**CULTURAL RESOURCES OFFICE  
PRESERVATION BOARD  
REGULAR MEETING  
MONDAY APRIL 27<sup>TH</sup>, 2009  
1015 LOCUST ST. #1200  
4:00 P.M.**

**Date:** April 27, 2009  
**To:** City of St. Louis Preservation Board  
**From:** Jan Cameron, Cultural Resources Office  
**Subject:** Preliminary Review Application: install wind turbines on roof of 3-story commercial/residential building  
**Address:** 6193 Delmar Boulevard  
**District:** Skinker-DeBaliviere Local Historic District

**Date:** April 27, 2009  
**From:** Jan Cameron, Preservation Administrator  
**Subject:** Preliminary review to construct 19 new residential buildings  
**Address:** 4100-56 DeTonty Avenue  
**District:** Shaw Neighborhood Historic District — Ward 17

**REVISED PROPOSAL**

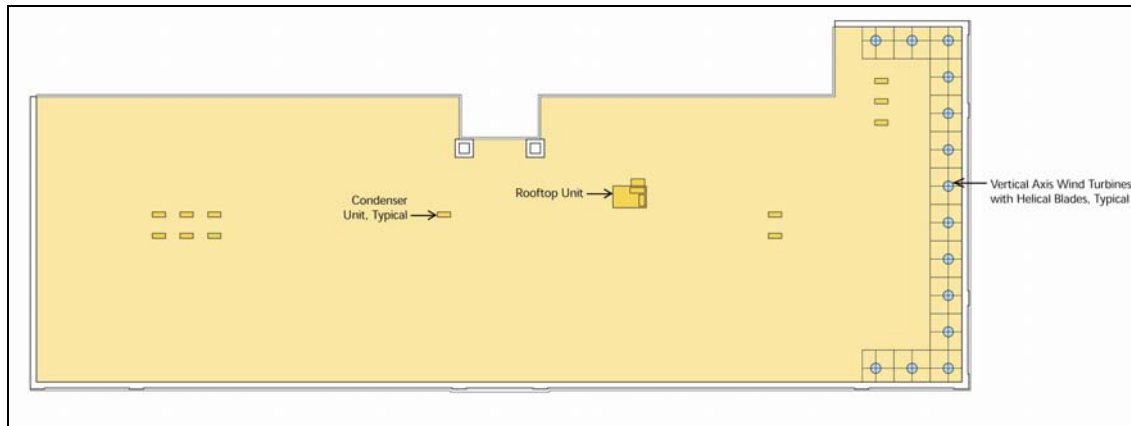
**Does not comply.** The installation of aluminum wind turbines on the roof deviates from the historic district standards. The larger, distinct turbines read now as individual mechanical units and no longer reference building cornices and roof-top appendages as in the original proposal.

6139 Delmar is located in an entertainment area that has recently undergone considerable investment as an entertainment, shopping and dining area. Many of the recently-constructed buildings have a lively, eclectic design. The original proposal would have created a dynamic and artistic addition to the building: at the staff's suggestion, the turbines and frame were to have been extended at each corner to reflect the architectural bays of the building and to accentuate the suggestion of an overscaled decorative cornice. The revised proposal loses that reference and the turbines seem merely mechanical devices.

The Cultural Resources Office staff recommends that the Preservation Board require that the installation follow the original concept or that the turbines be relocated to an area of the roof that will substantially reduce their visibility from the street.

PROJECT STREETSCAPE

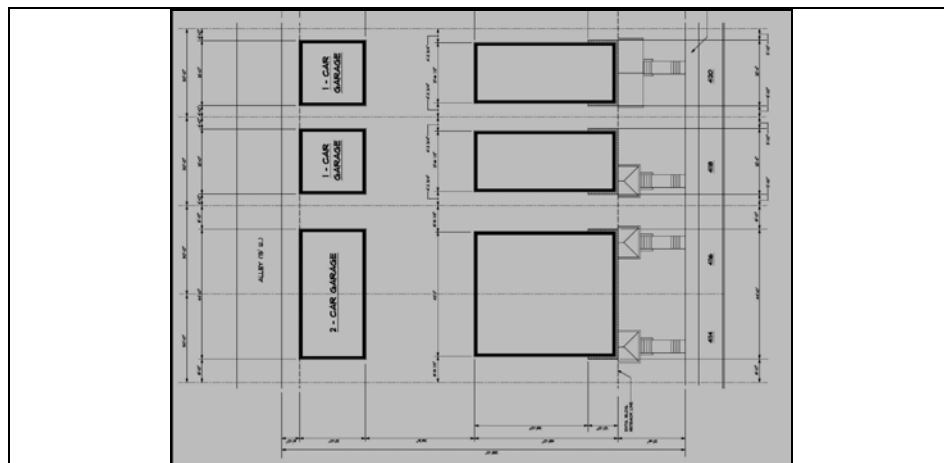
**Appears to comply.** The heights of the cornice lines of the new construction appear to be close to those of adjacent historic buildings as does the first floor elevation about grade; however, the staff has not seen a scaled elevation of the block that includes the existing buildings.

**Mostly complies.** The new buildings will conform to all required setbacks; widths are consistent with historic structures. Building spacing will be somewhat wider than is typical in the district, with gangways of about 10 feet instead of the more usual three feet between buildings.

SITE PLAN DETAIL

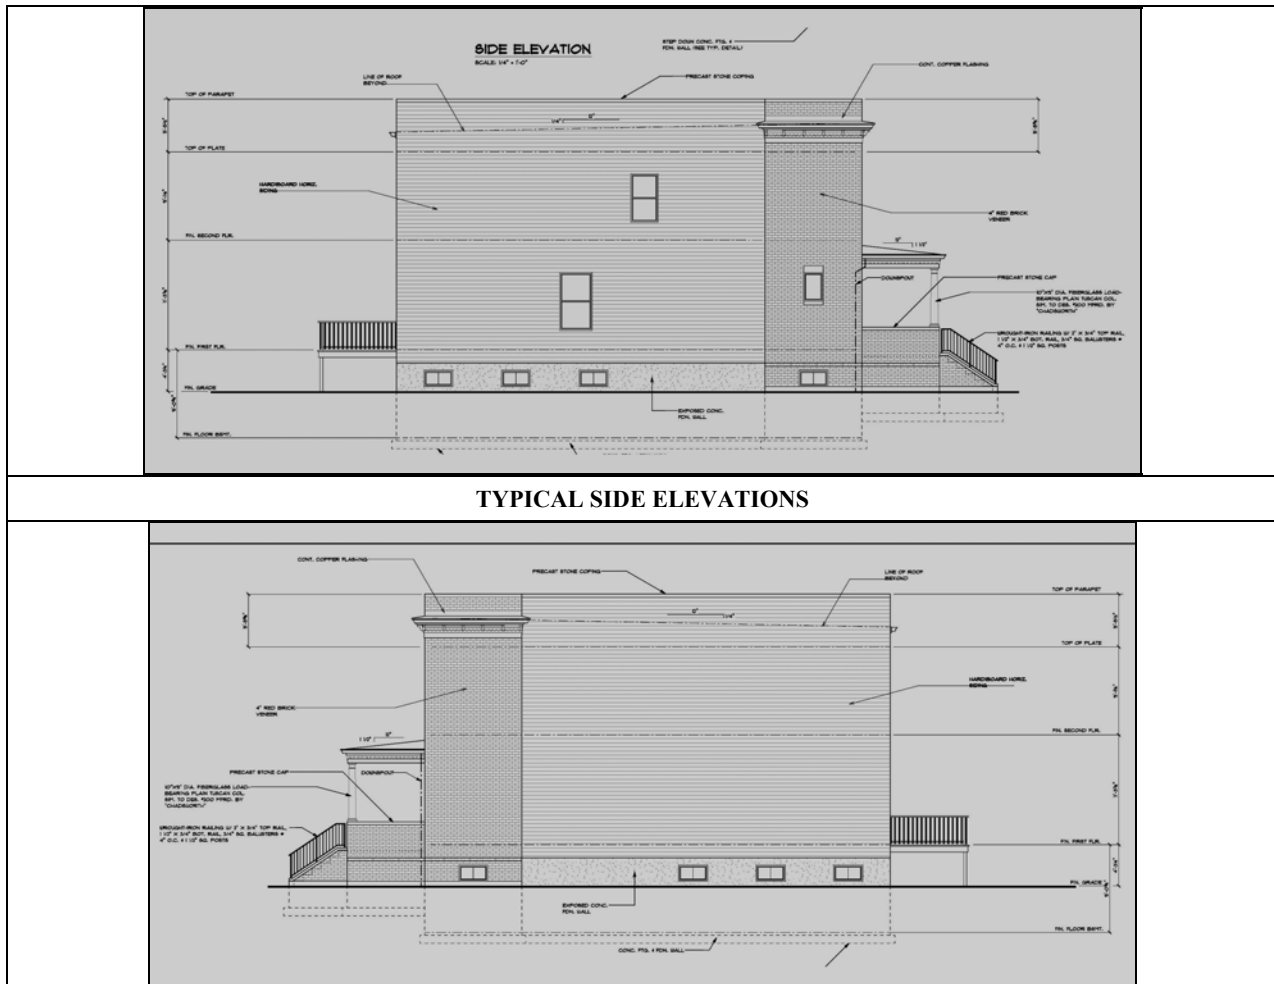
**Complies.** The front facades and front foundations will be faced with brick. The side elevation of the corner 2-family building will also be brick. On the other buildings, the brick will return 10 feet on each secondary elevation, the width of the sideyard.

PROPOSED 2-CAR AND 4-CAR GARAGES

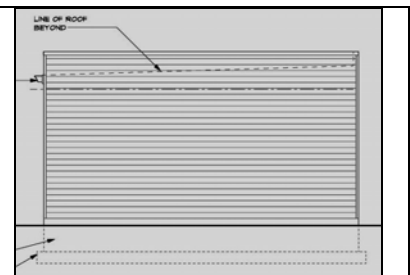
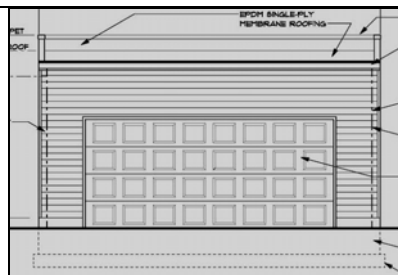
**Complies.** Each house will have a detached frame garage at the rear alley.

4100 DETONTY TODAY

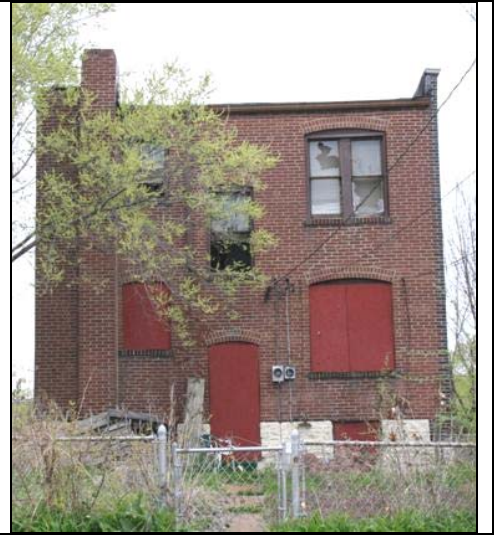
However, the staff does not support the proposed demolition of the corner building at 4100 DeTonty. It appears to have deteriorated little since 2006 and is structurally sound — an excellent candidate for reuse. The building is eligible for historic tax credits that would assist in its rehabilitation, which should be required for the approval of this project..

The Cultural Resources Office staff recommends that the Preservation Board grant preliminary approval to the design of the proposed new construction, with the stipulation that 4100 DeTonty be rehabilitated as part of the project. Final construction documents and selection of final finish materials should be submitted for the Cultural Resources Office staff's approval.
